Project: St Michael Catholic School Ridgetown
Childcare Retrofit & Office Renovations
25 Maple Street
Ridgetown, Ontario

Project ID: ROA15-008
Client No.: 640-CP1502
Addendum: 3

REVISED DOOR & FRAME CORRIDOR 104 & SIDEWALK REVISIONS

01 PARTIAL SITE PLAN - BACK COURTYARD
 SK101 SCALE: 3/32" = 1'-0"

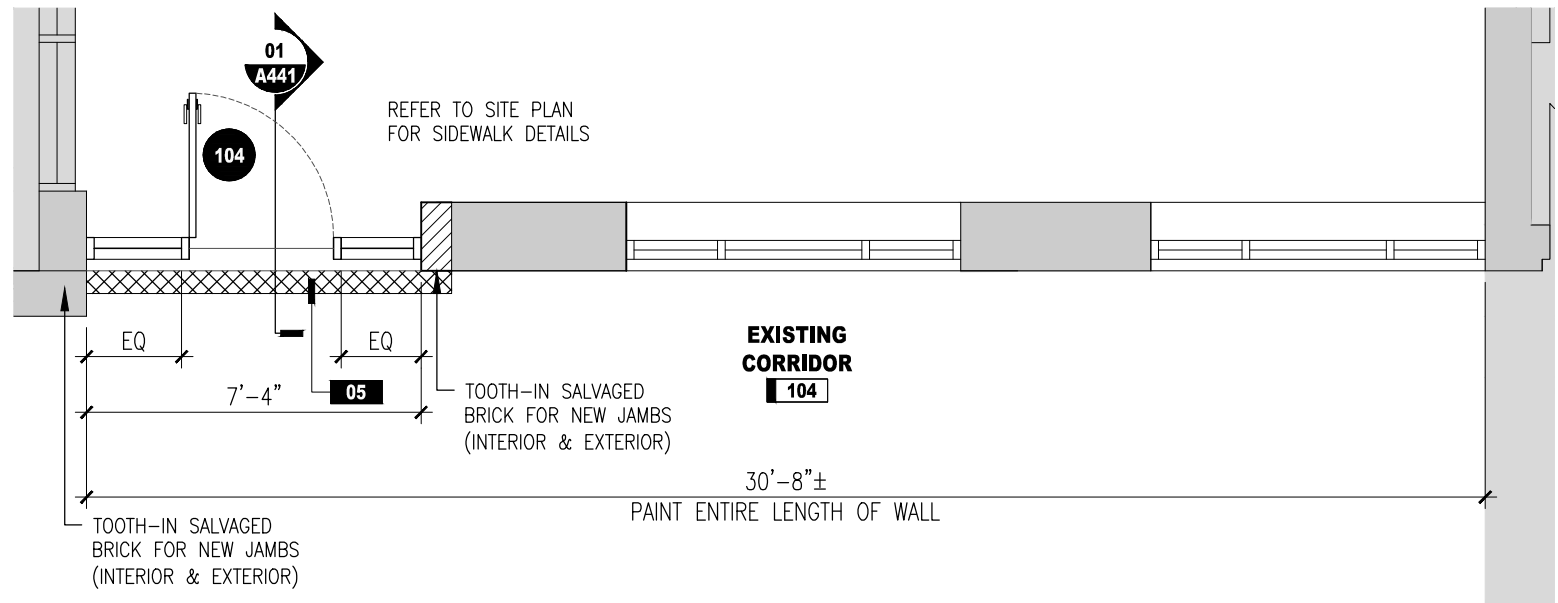
- .1 Relocation of door 104.
- .2 Relocation and re-configuration of exterior sidewalk and associated grading.
- .3 Refer to detail 3 on SK101 New Frame type 'D' for relocated door 104.
